Memorandum

To: OW Practitioners
From: Craig Sanders, Environmental Program Manager (303) 271-5759 csanders@jeffco.us
Date: April 26, 2018
Re: Major changes in 2018 OWTS Regulations for Jefferson County

4' Separation Required

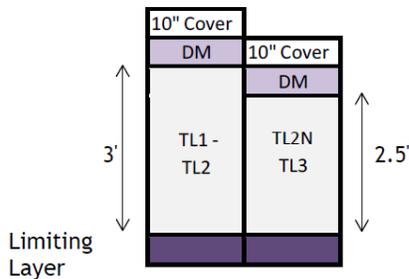
PG 69 (Section 15) There have been changes in the vertical separation distances within an STA. Please see the form at the end of this memo for calculating distances from an infiltrative surface to limiting layer within an STA – there have been several important changes.

For all OWTS that receive TL1 effluent and utilize gravity flow in soil types 1-5, a 4' separation above a limiting layer is required

For the repair of an existing OWTS, or for the installation of a new OWTS, TL2-TL3N may be applied by gravity flow to the STA only in Soil Types 3A-5, (For designs requesting reductions in STA size or vertical/horizontal separation with the application of TL2 - TL3N effluent, pressure dosing is required as noted in the sections below)
